Sub: Corrigendum-01: Amendment to Tender specification document & due date extension

- 1. E-Tender specification No: 2101094
- 2. **Scope of work:** Detailed drawing preparation based on Input design drawings provided by BHEL-Engineering Centers for Flue Gas Desulphurization (FGD) Package as specified in scope and getting approval from BHEL- Engineering Centers/ NTPC. Fabrication and supply of finished product (procurement of raw structural steel will be in the scope of bidder) i.e. structures of FGD as per BOM/Drawings at 2X500 MW NTPC Mauda, Stage-I, TPP-FGD, Maharashtra.

2 X 500 MW MAUDA STPP-FGD PACKAGE			
DWG / DOC NO AND TITLE : 9561-109-ISG-PVC-B-445 - CONVEYOR LBC-1AB-GA OF GALLERY & TRESTLES R0				
SL NO	NTPC COMMENTS	BHEL REPLY		
1	Hold	Staad file has been revised and errors resolved		
2	PTFE bearing shall be provided for slinding support	Accepted. PTFE indicated in elevation view.		
3	COMPLY TO COMMENTS MARKED DESIGN DOCUMENT	Complied		
4	DESIGN/DRAWING TO CONFORM TO LATEST MECHANICAL/ELECTRICAL GADRG.	Accepted. Trestle Tr-2A introduced for structural requirement, after discussion with mechanical. The same will be updated in Mech GA dwg.		
5	ALL FURTHER CHANGES TO BE I

location: NTPCEOC

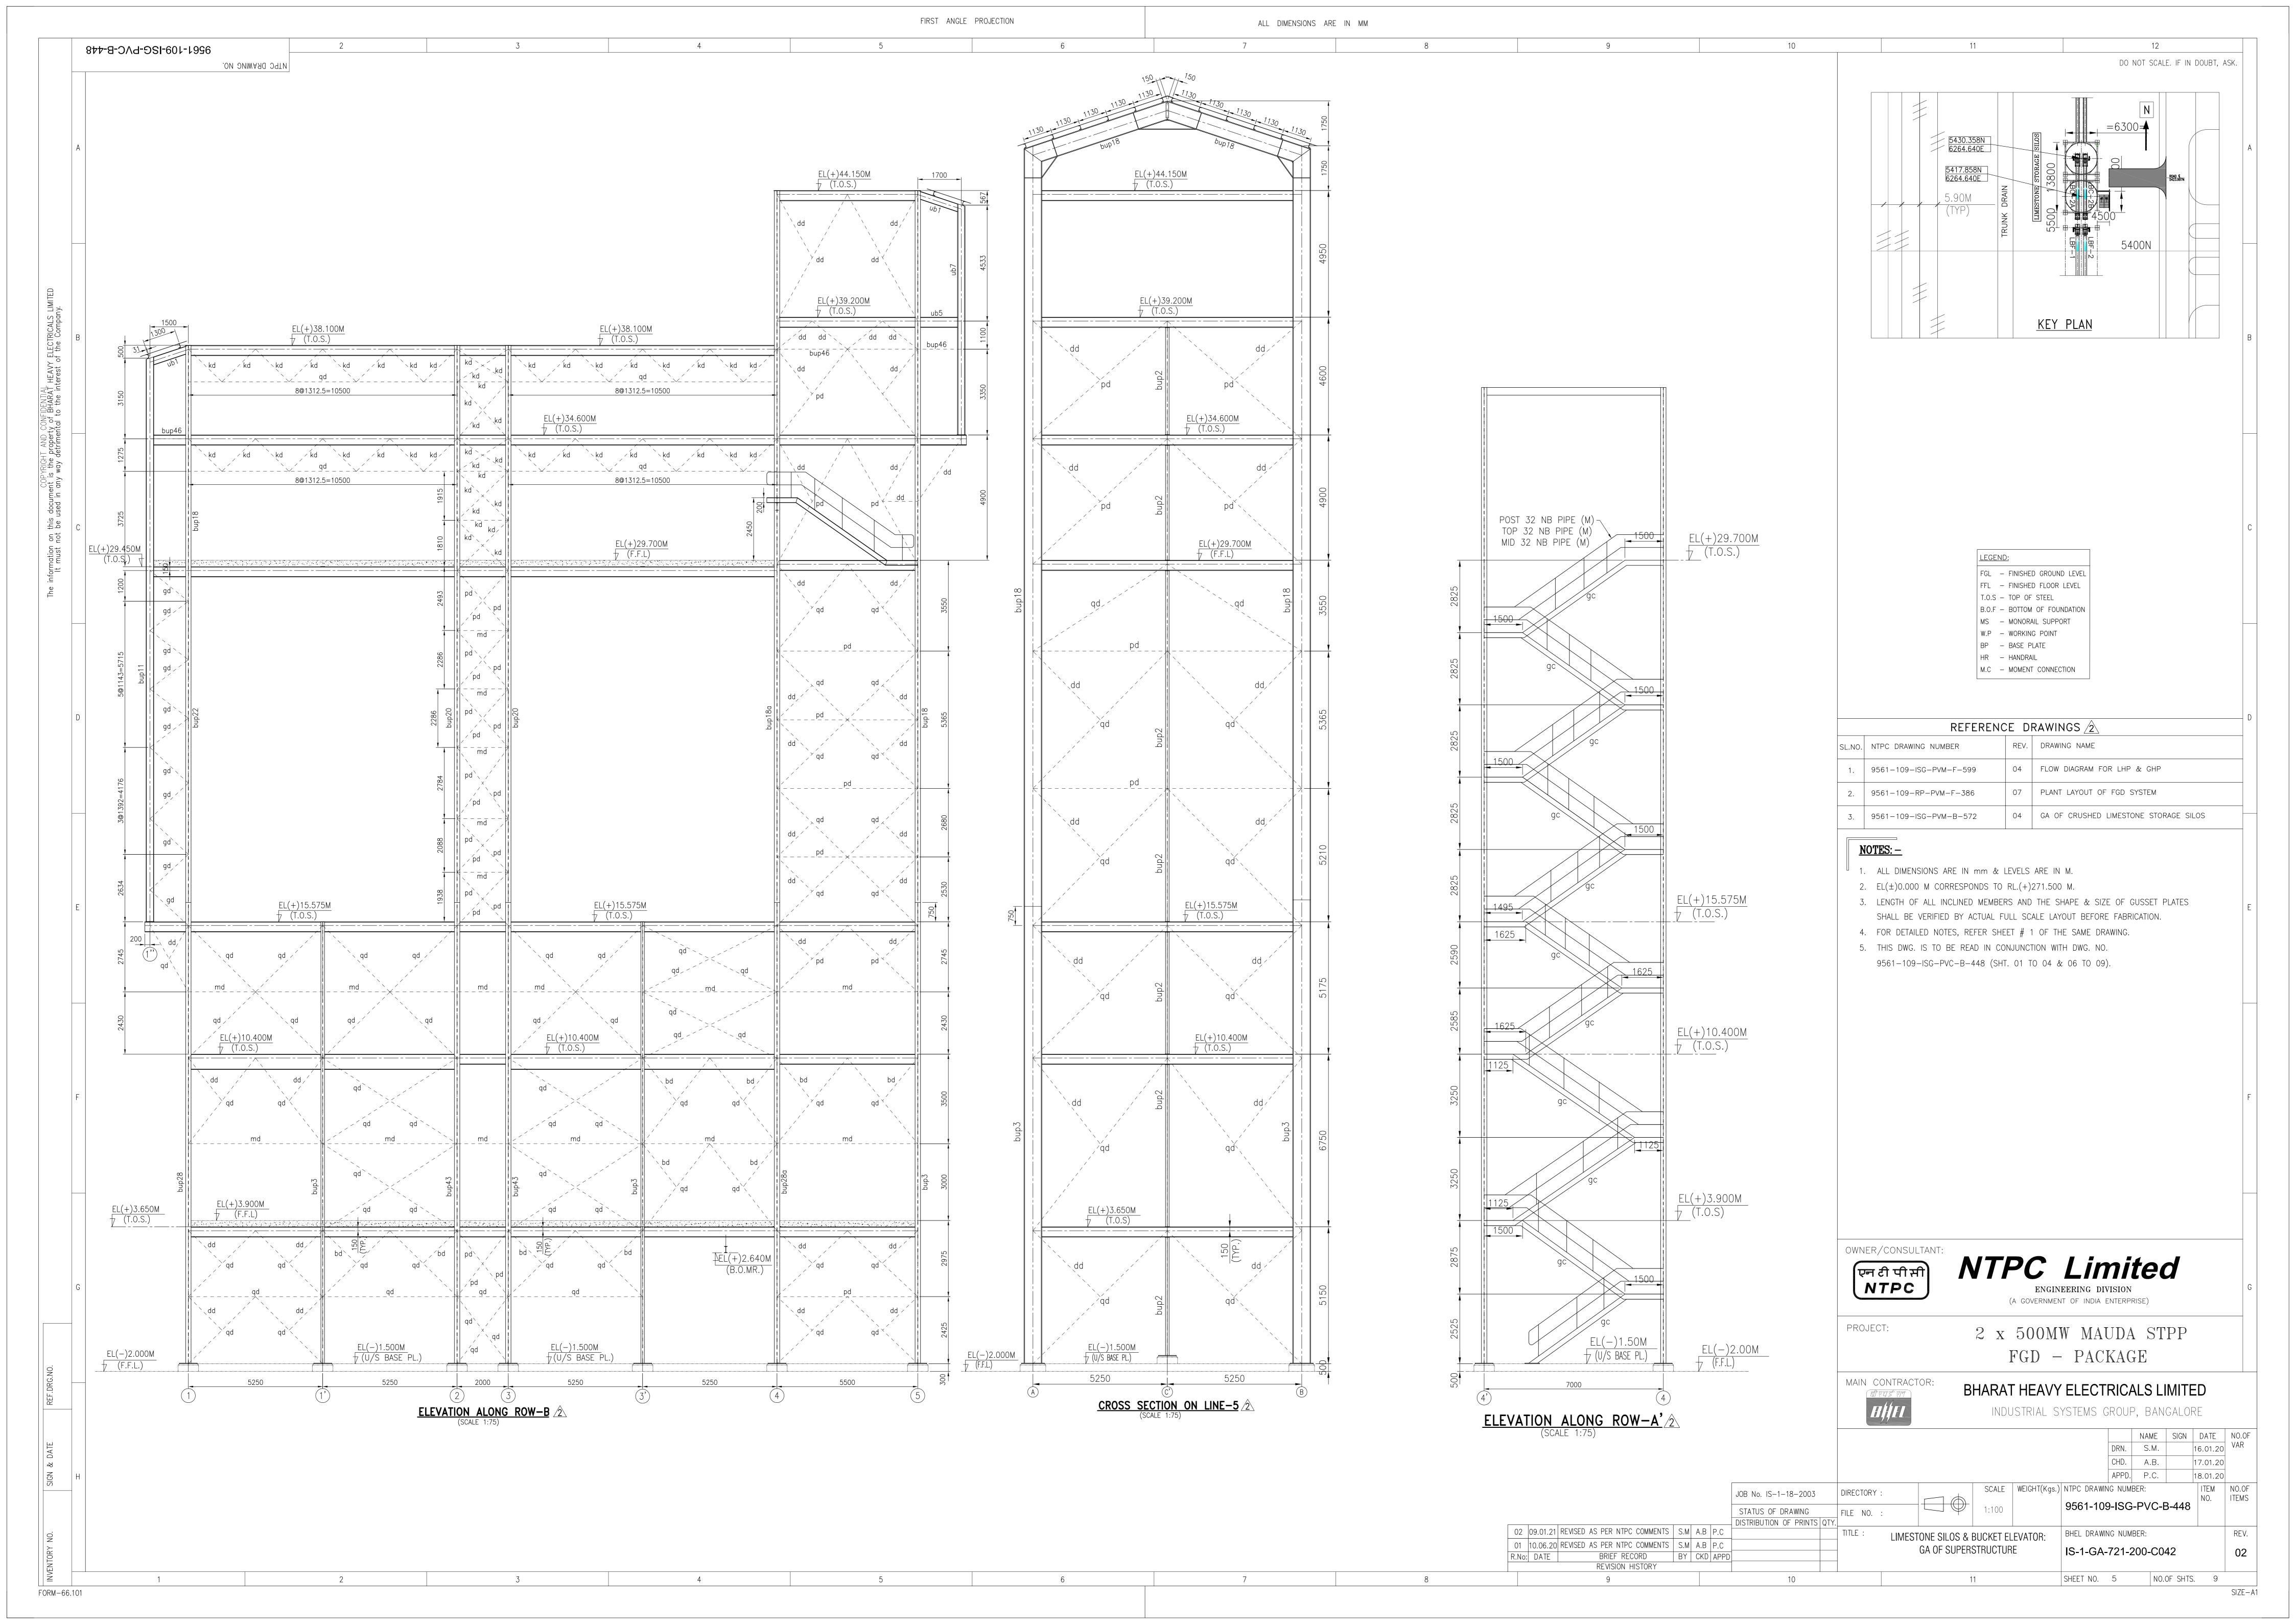
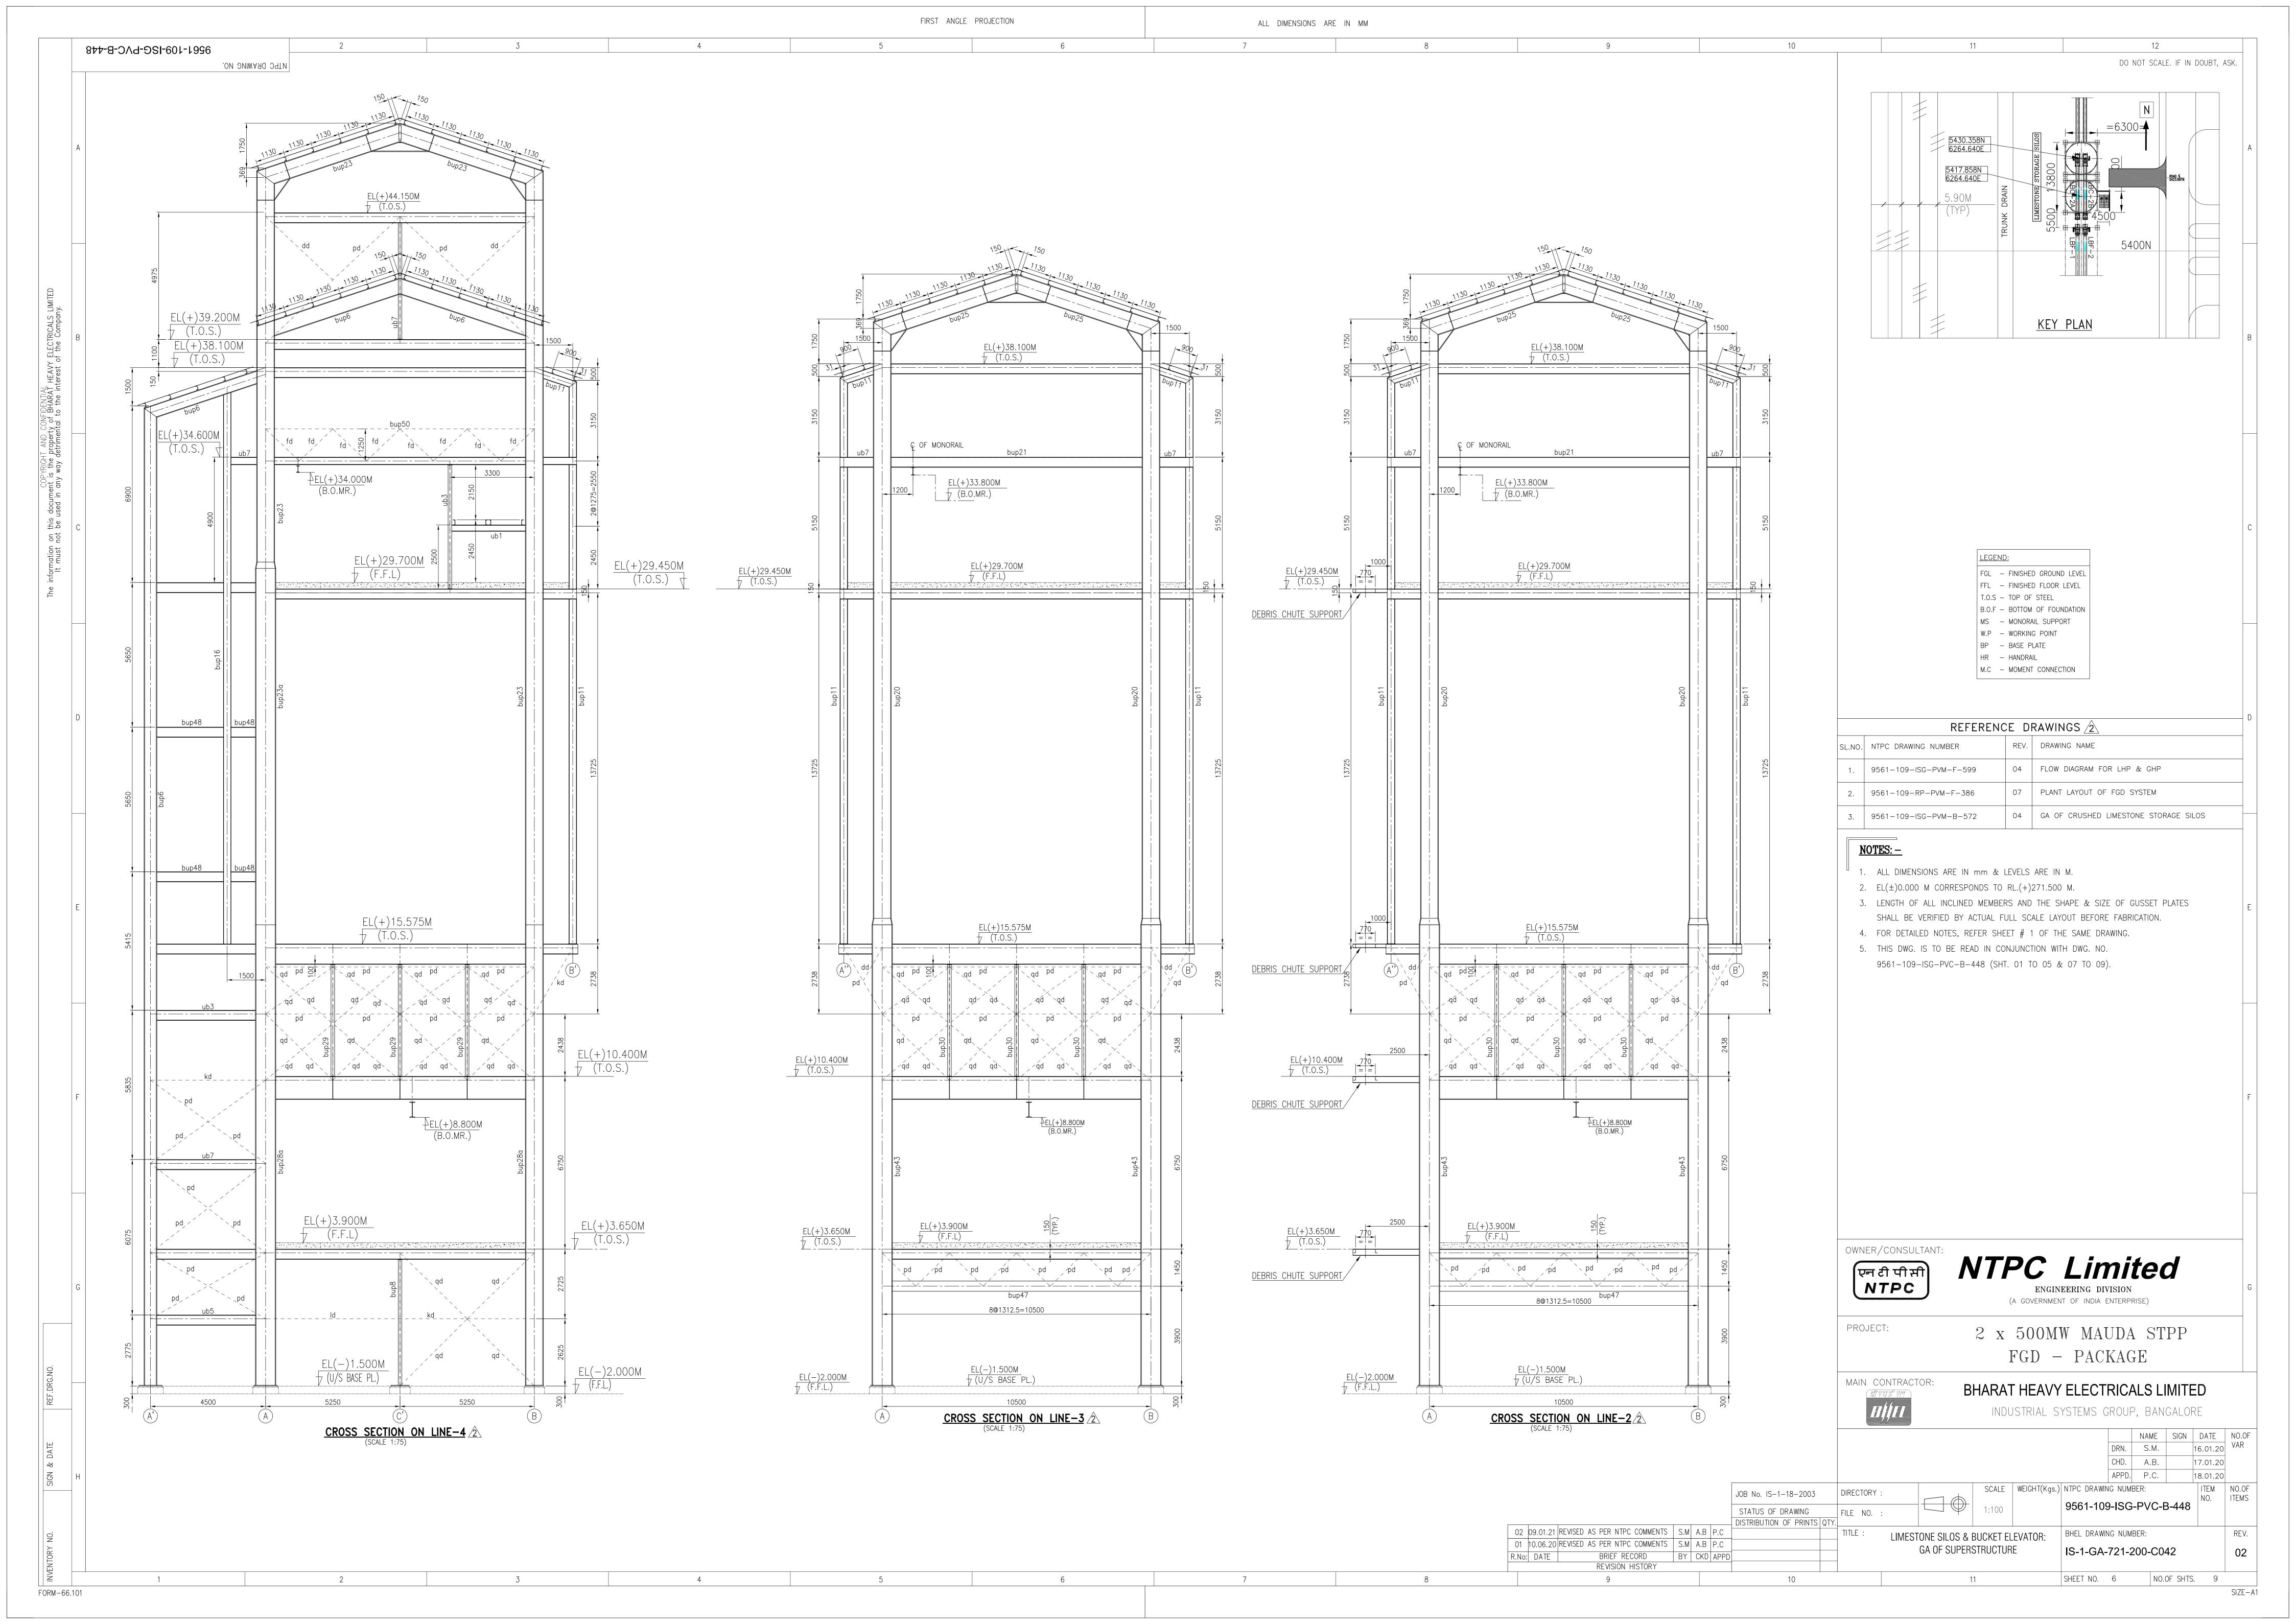
COMPLIANCE SHEET		
2 X 500 MW MAUDA FGD PACKAGE		
NTPC DWG / DOC NO AND TITLE : 9561-109-ISG-PVC-B-448 - (Limestone Silos-R1)		
SL NO	NTPC COMMENTS	BHEL'S REPLY
1	Compliance of observation marked in the design document required	Incorporated comments in the latest revision of drawings.
